An inescapable truth - **there are no drawings that show an approved height of 15.5m.** The detail used by Planning and repeated by the Head of Development Services in his response to our Petition is a mistake on a drawing (1A or 1B) that has neither been approved nor authorised.

The drawings used by UK Docks and their promoter South Tyneside Council are either 8296/1A or 1B which are not authorised and contain a **fundamental drawing error.**

8296/2 is the only authorised drawing from 1996 in the Council's possession with dimensions. The detail on the LHS gives an approved height of the landward gable of 12.7m.

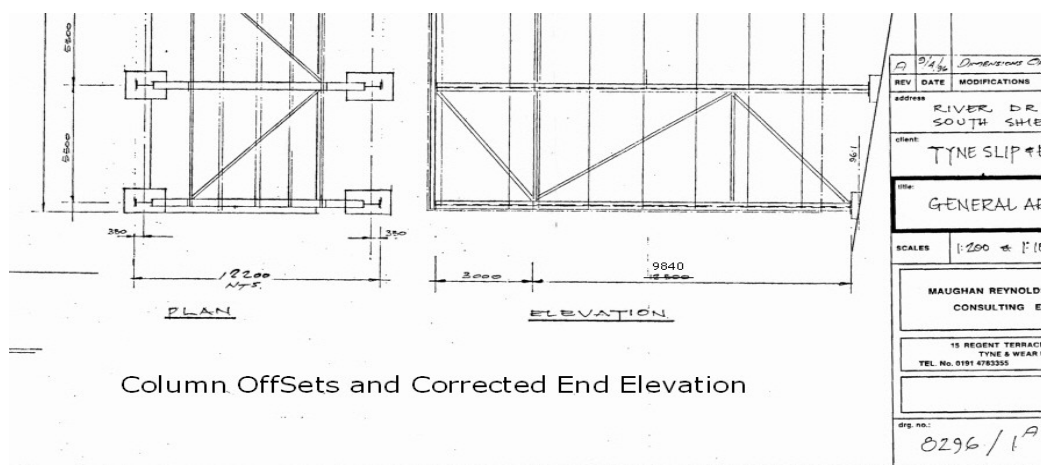
Height = 12.7m (roof = 108.8 and base = 95.5m (96.1m from 8296/1A or B))

Column Offsets and Corrected End Elevation

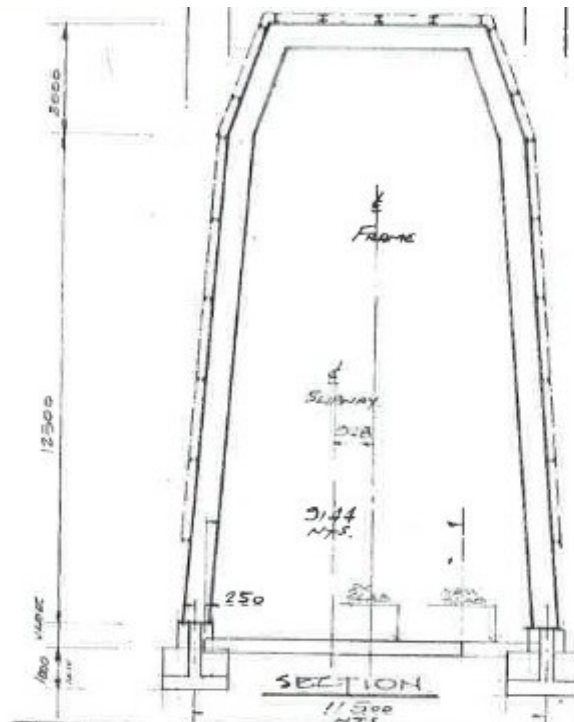
Even without using a scale ruler on a full sized drawing one can see that the dimension at the landward end of the shed is wrong. The 3000, roughly a quarter of the whole, nearly half way to a mid point line, confirms this. Three is a quarter of 12 not 15. (The 9840 is calculated from measurements taken from a screen. The Local Government Ombudsman

was given a recalculation of 9750 (12.75m for the whole length) using a full sized drawing. If one looks at the top of either drawing one will see that the river end is shown as 15.5m as well and as there is a gradient (2.7m) between the ends only one of them can reflect the planned height of the roof (or the roof would slope downwards toward the river). $15.5 - 2.7 = 12.8\text{m}$ which nearly agrees with the approved/authorised drawings.

18.2m at the river end (15.5+2.7) as suggested by the Planning Manager is false, a statement to save the Council taking enforcement action.
